I Drive Cycle Equivalency During “A” to “B” Testing

EPA has proposed utilizing “A” to “B” testing in several areas of its proposed Medium- and Heavy-Duty (“MD/HD”) Greenhouse Gas (“GHG”) and Fuel Efficiency (“FE”) Standards. For example, this testing protocol may be utilized in Part 1036, Subpart F for certain hybrid engines with PTO capability when the engine is coupled with a transmission; Part 1037; Subpart G for hybrid powertrains; Part 1037, Subpart F section 1037.525 for hybrid vehicles with PTO; and Subpart F section 1037.610 for hybrid vehicles and other advanced technologies.

In comments filed on January 31, 2011, Allison Transmission, Inc. (“ATI”) outlined several issues concerning the drive cycle testing of MD/HD vehicles, including the ability of vehicles to follow a “trace,” the proposed criteria for determining compliance, the proposed “A” to “B” testing of hybrid technologies and other issues.¹ ATI also submitted numerous questions on the proposed definitions of hybrid systems, testing systems for hybrids, the configuration of test vehicles, how “real world” comparison vehicles would be determined and other matters.²

Example traces for which the above-described procedure number 3 could be implemented are shown below:

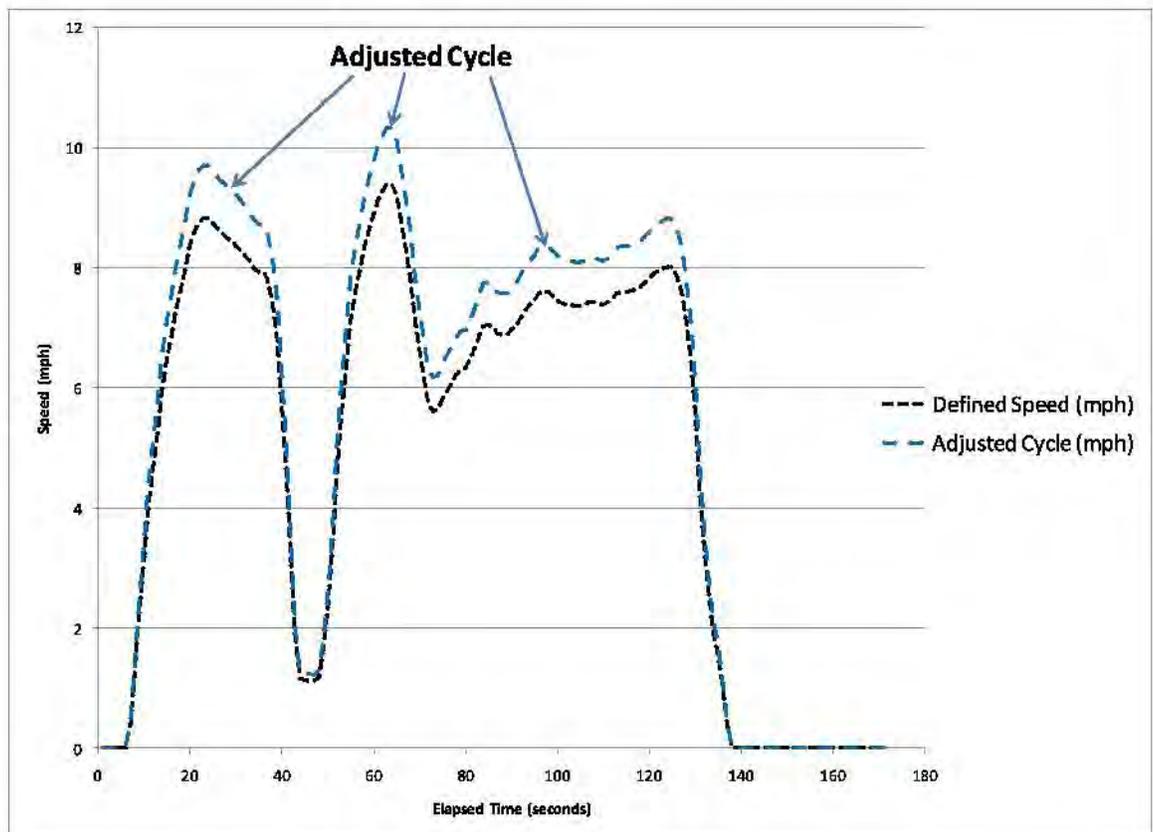
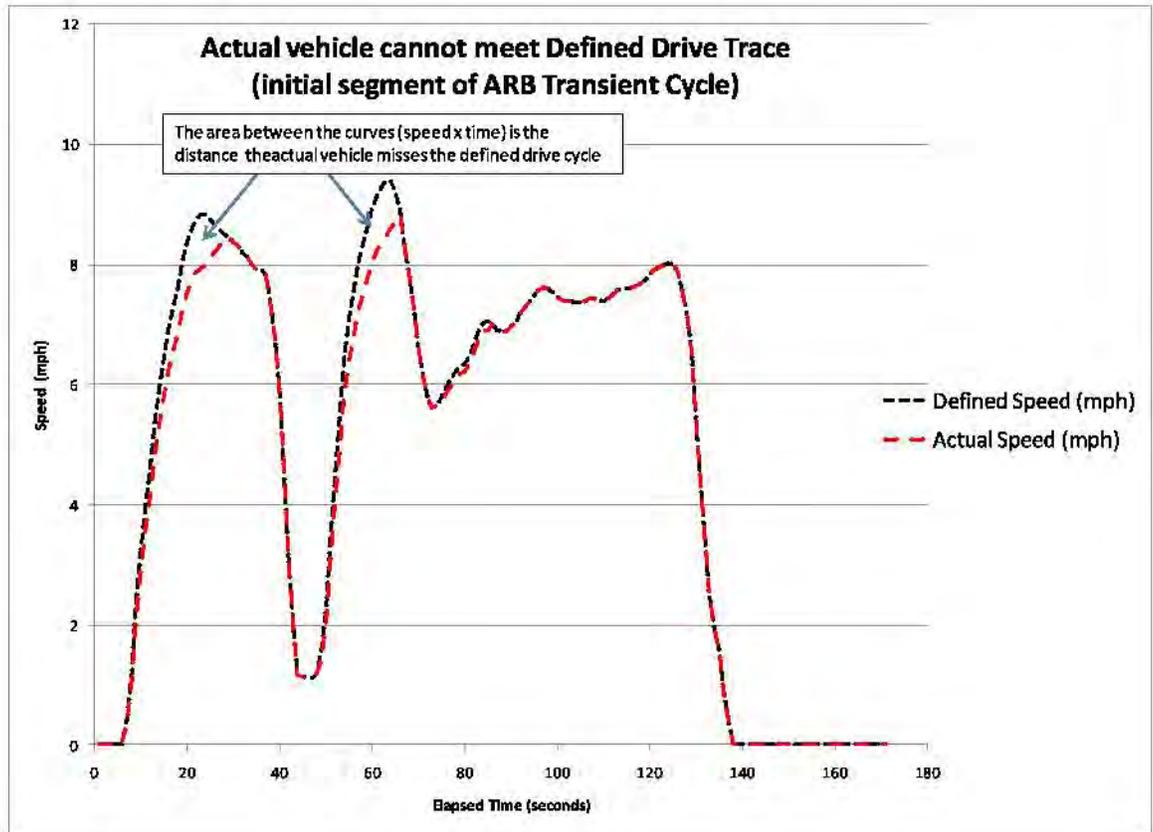
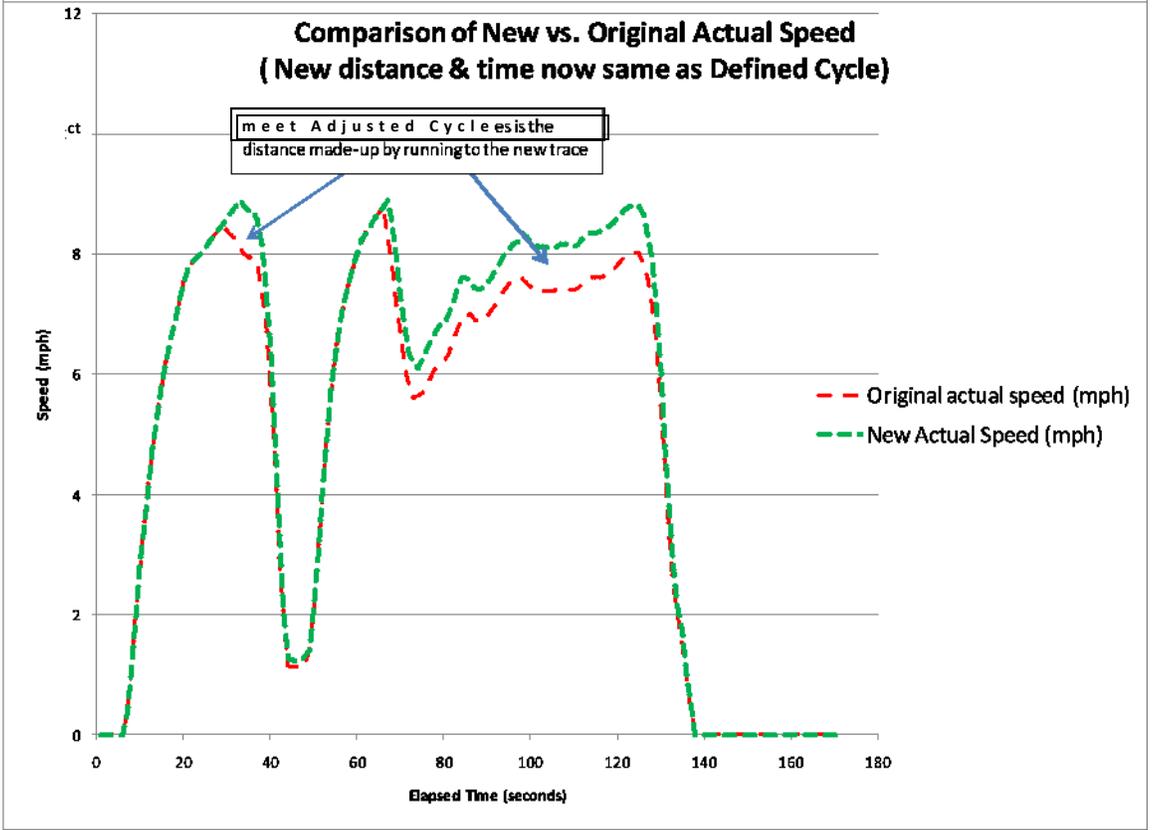
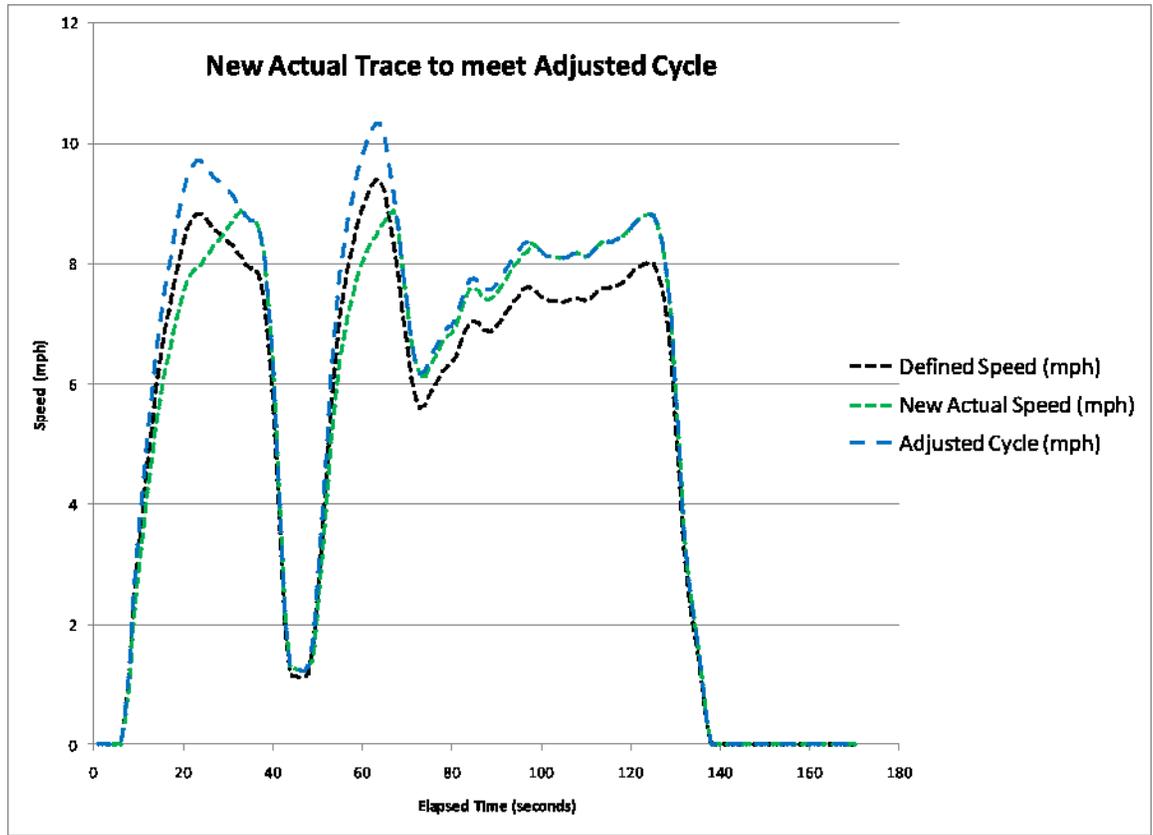
1. Adopt the EPA criteria that the speed trace is followed within 2 mph within a 1 second window unless at maximum effort (reference “maximum effort” criteria), but add the following requirement:

- a. Total distance traveled has to be within 1% of theoretical.
2. Clarify that if condition specified in 1 a. is not met, the test must be re-run until the requirement is met. This would insure that both time and distance are equivalent (within 1%) for configuration A and B.

3. If 1 a. still cannot be met due to vehicle not being able to follow the trace, then the speed trace could be increased by a factor (for example: theoretical distance / actual distance) and the cycle would be rerun. This process could continue until item 1 a. (referenced to the original speed trace) is met.
